## MEMORANDUM

Re: Firehouse Plaza Site Plan Amendment - Follow-up Information

In your email of 10/24/13, you requested additional information to complete the site plan application for the Automotion-Giroux lot, tax parcel 20-50-02.200. We provided the additional information to the Town on 11/7/13. On 11/12/13, you had follow-up questions (shown below in red), to which we are providing the following responses (in blue).

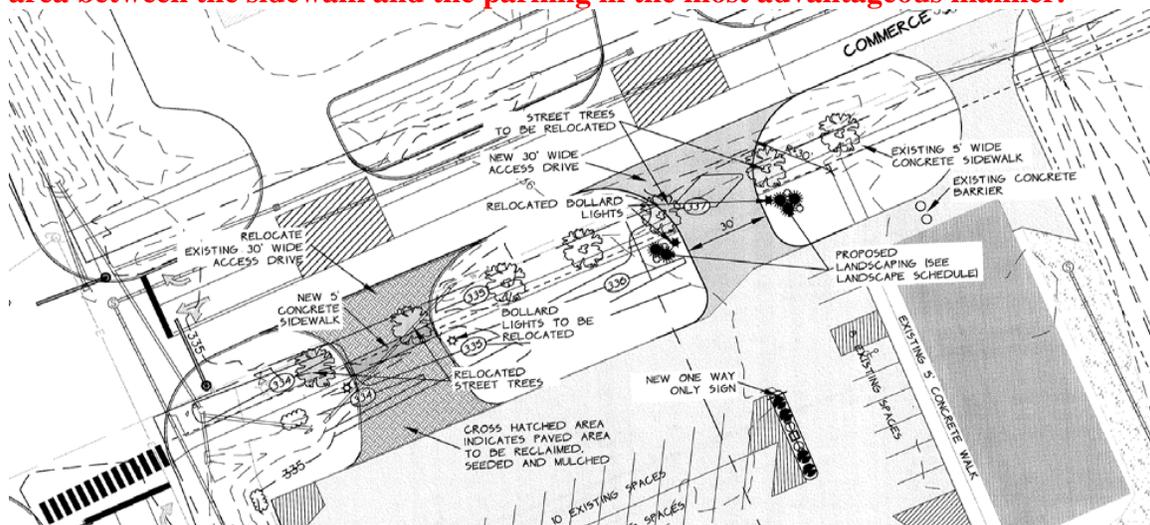
*Town Request (10/24/12): Need more information regarding bollard lights. Need to demonstrate adequacy of exterior lighting for safe circulation on the site without creating off-site glare and excess illumination. Please supply spec. sheets on the bollard lights. Per section 4.3.4(4) of Hinesburg Zoning Regulations*

**Town Follow-up (11/12/13):** This existing bollard lights don't meet the Hinesburg Zoning regulations due to the fact they are not shielded and are not downcast. *Per Section 4.3.4 (4) and Section 5.6.4*

**Application Response (11/7/13):** The two bollard lights being shown at the relocated entrance are the approved fixtures from the existing access drive location. These will be located proximate to the driveway exactly as they are today - same distance from the road and setback same distance from the driveway itself.

**Applicant Follow-up (11/26/13):** Understood. We will review and provide a resolution to this issue before or at the meeting with the DRB.

## TREE PLANTING/RELOCATION DETAIL

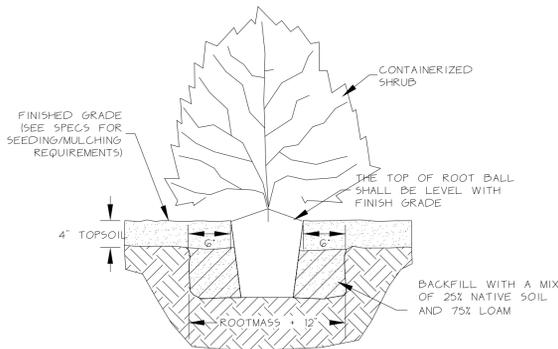
**Town Follow-up (11/12/13):** Please provide proof that these existing street trees are able to be transplanted; are they any water lines, etc. preventing them from being tree spaded?

**Applicant Follow-up (11/26/13):** There is an existing waterline located approximately 5' from the existing street trees. It is expected that this will not prevent the trees from being relocated. However, as with any standard tree relocation, the contractor will need to determine if these are unable to be relocated when in the ground. If there is a conflict underground and they cannot be relocated, they would be replaced.

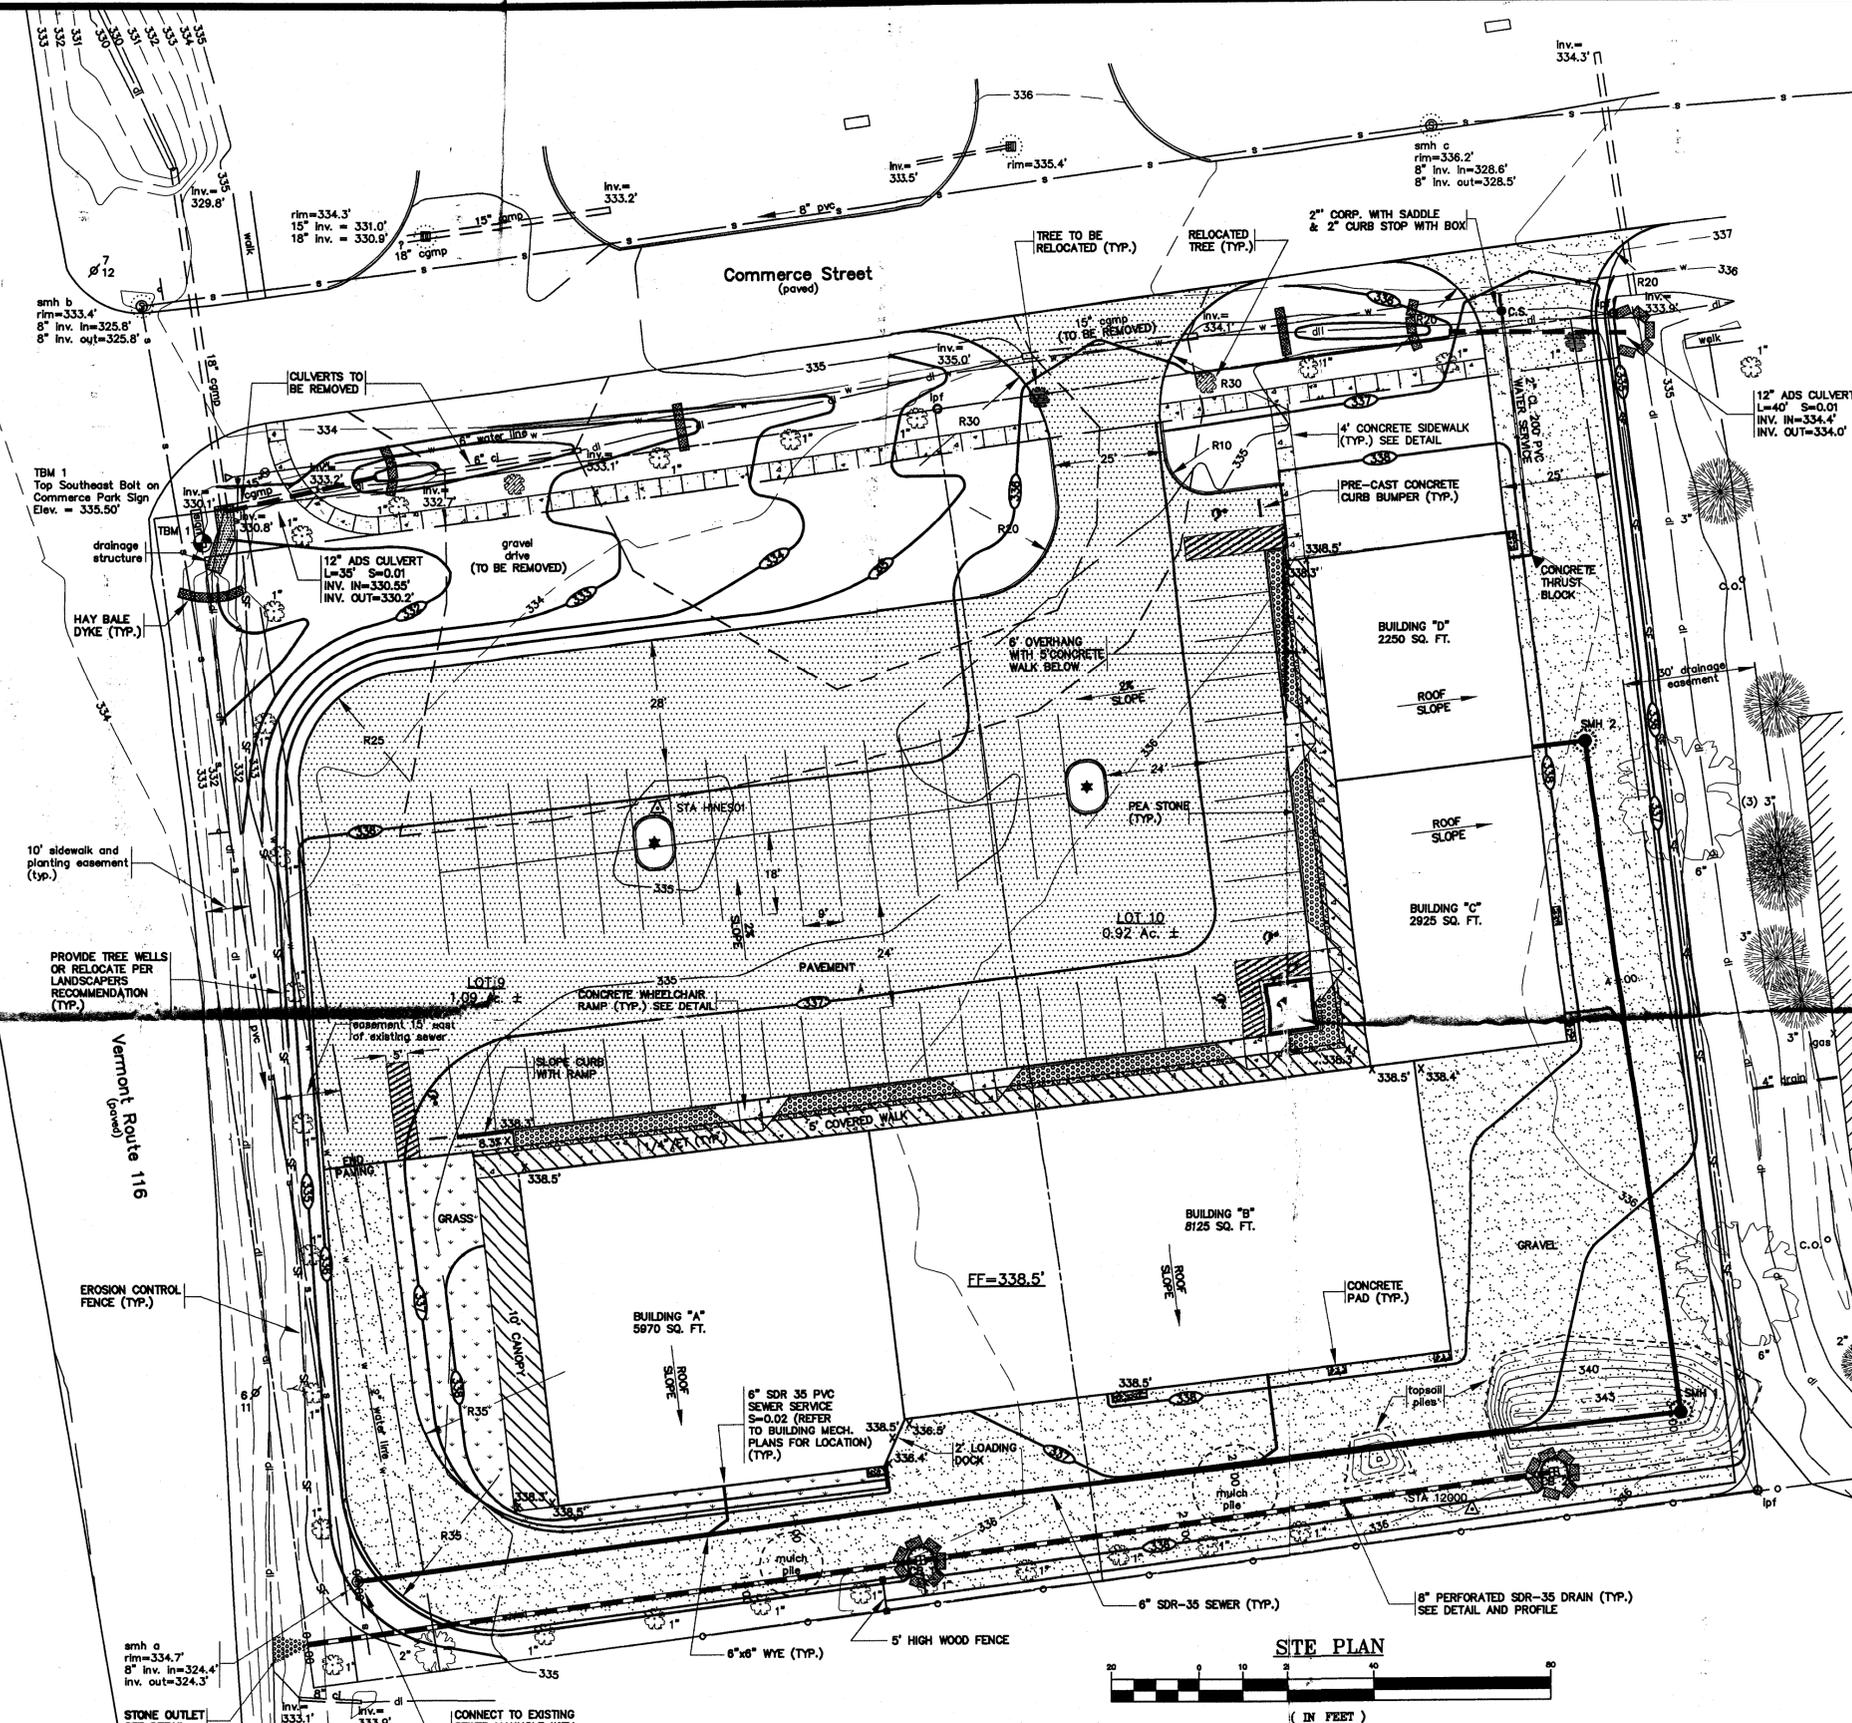
**Town Follow-up (11/12/13):** Per the site plan below it appears that when the driveway is removed the culvert under it will be removed as well and the existing swale is proposed to simply be continued across the area where the driveway was. Either a designed and permanent sheet flow from the parking area into the swale should be established, or if the flow from the parking area is concentrated, it should be directed in to a stormwater control device i.e. a serpentine swale or the equivalent located between the parking area and the sidewalk. Please delineate where the stormwater flow from the northern edge of the parking area currently flows and include a proposal on how it will be controlled and cleansed utilizing the area between the sidewalk and the parking in the most advantageous manner.

**Town Follow-up (11/12/13):** Please explain how the stormwater will get from the area between the new driveway and the service driveway, located to the east of it. There is anecdotal information that in periods of flooding the existing culvert actually backflows bringing stormwater from the swale between Darkstar and the plaza to the north instead of draining this area. This must be addressed in this application since the new driveway will create a new situation and the existing situation, as far as I know was never approved as part of the Commerce Park stormwater design.

**Applicant Follow-up (11/26/13):** This amendment will result in slightly reduced lot coverage and increased stormwater treatment. The current proposal to relocate the entrance to the shopping center will not change existing flow patterns. Stormwater runoff from the northern edge of the parking area will continue to flow to the grassed swale located between the sidewalk and parking lot. The culvert under the existing entrance will be replaced by the extension of the grassed swale - extending the length of the swale from 140 feet to 185 feet. This will increase the level of treatment. Grassed swales (channels) have been proven effective in the removal of total suspended solids, phosphorus load, longevity in the field, and are listed as an acceptable method of treatment in the 2002 Vermont Stormwater Management Manual.

**Applicant Follow-up (11/26/13):** Stormwater in the area east of the proposed access drive currently flows east to the swale between Firehouse Plaza and Darkstar. This will remain unchanged by the proposed access drive. This configuration and flow was originally constructed and approved by the VT Stormwater Division, as can be seen on the attached SH 1 "Site Plan," prepared by Phelps Engineering Inc., and dated 4-16-96. This is also how it is approved on Sheet C4 "Commerce Street Utility Plan," dated 11/9/10, and revised 4/26/12 of the Hannaford approval. This proposal does not alter the existing flow and complies with the stormwater discharge permit 3034-9010.R.
